## Certificate of Appropriateness

**Property** 2824 W. STATE ST. Concordia Historic District

**Description of work** Repair/replace deteriorated cladding such as clapboards and decorative shingles on the full

**Date issued** 9/21/2017 PTS ID 114391 COA: siding

Porch section approved for repair.

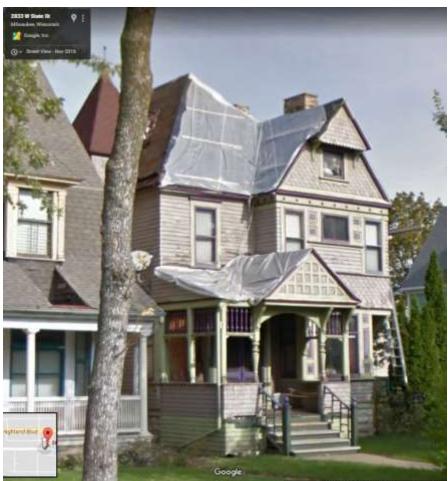
Front porch trim is not to be touched or altered other than replacing the interior siding of the front porch ("car siding" tongue and groove) and replacing the skirting to match existing shingles. No repairs or alterations to the gingerbread work at the top of the front porch, the top rail of the porch wall, or to any of the front porch columns are permitted by this certificate.
